Prairie Island Nuclear Generating Plant Units 1 and 2
Dockets 50-282 and 50-306
License Nos. DPR-42 and DPR-60

Supplement to License Amendment Request (LAR) To Technical Specification (TS)
5.5.14 For One-Time Extension Of Containment Integrated Leakage Rate Test Interval
(TAC Nos. MC9272 and MC9273)

Enclosure 1 provides the NRC RAIs and NMC responses. Enclosure 2 provides a description of the probabilistic risk assessment model used to respond to question 1 and the results of the evaluation.

NOTE (1): The value of 1.56E-5/yr for 0.39g was obtained from interpolation of values on the NUREG-1488 seismic hazard curve (see Figure A-1 below).

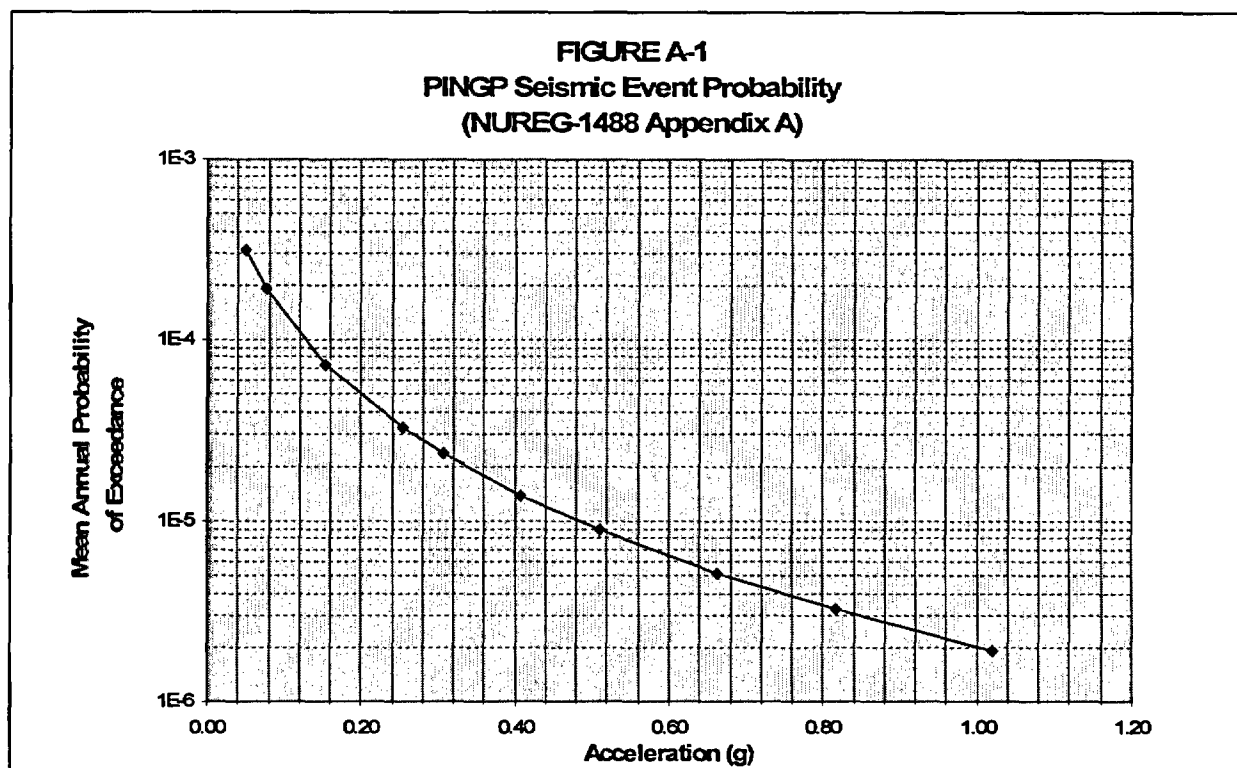
- 1. The approach used to assess the risk impact of the integrated leakage rate test interval extension considered only internal events risk. As stated in Section 2.2.4 of Regulatory Guide 1.174, the risk-acceptance guidelines (in this case, for large early release frequency (LERF)) are intended for comparison with a full-scope risk assessment, including internal and external events. Consistent with this guidance, and to the extent supportable by the available risk models for Prairie Island, provide an assessment of the impact of the requested change on delta LERF and total LERF (based on the Nuclear Energy Institute Interim Guidance Methodology) when external events are included within the assessment.**

The seismic hazard curve for PINGP was obtained from NUREG-1488 [A-4]. It is replicated below with the PINGP HCLPF of 0.39g PGA estimated from the available data points and added to Table A-1.

$$CDF_{SEISMIC} = 0.5 * H_{10\%} = 0.5 * 1.56E-5/yr = 7.82E-6/yr$$
